Re: Case No. 20-417-EL-BGN - In the Matter of the Application of Grover Hill Wind, LLC for a Certificate of Environmental Compatibility and Public Need to Construct a Wind-Powered Electric Generation Facility in Paulding County, Ohio.

Response to Sixteenth Data Request from Staff of the Ohio Power Siting Board

**GROVER HILL WIND, LLC 'S
RESPONSE TO THE SIXTEENTH DATA REQUEST
FROM THE STAFF OF THE OHIO POWER SITING BOARD**

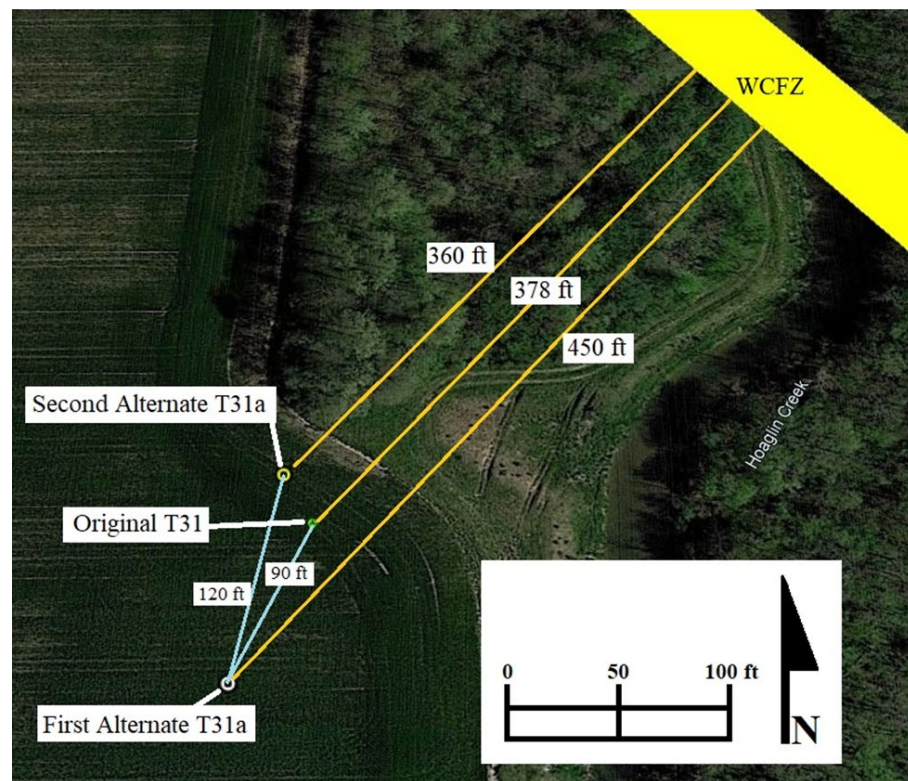
1. **In the Fifth Supplement to Application, Geotechnical Report, Appendix A (Soil Boring Logs), Staff notes that at least the boring location coordinates (i.e., latitude, longitude) of the soil borings for T-31a, T-34a, and T-43a appear to be incorrect. Please provide an updated Appendix A (Soil Boring Logs) with the corrected boring location coordinates and corresponding turbine number.**

Response: The decimal degree latitude and longitude values for three of the four Soil Boring Logs submitted in Appendix A of the Fifth Supplement to the Application were inadvertently transposed. This issue has been rectified and the corrected version of Appendix A to Attachment C, the Geotechnical Investigation Report, submitted with the Fifth Supplement to the Application filed on July 21, 2022, has been corrected and is attached to this response as Attachment 1. Attachment 1 replaces and supersedes Appendix A to Attachment C, the Geotechnical Investigation Report, submitted with the Fifth Supplement to the Application filed on July 21, 2022. All other information in Attachment C submitted on July 21, 2022, remains the same.
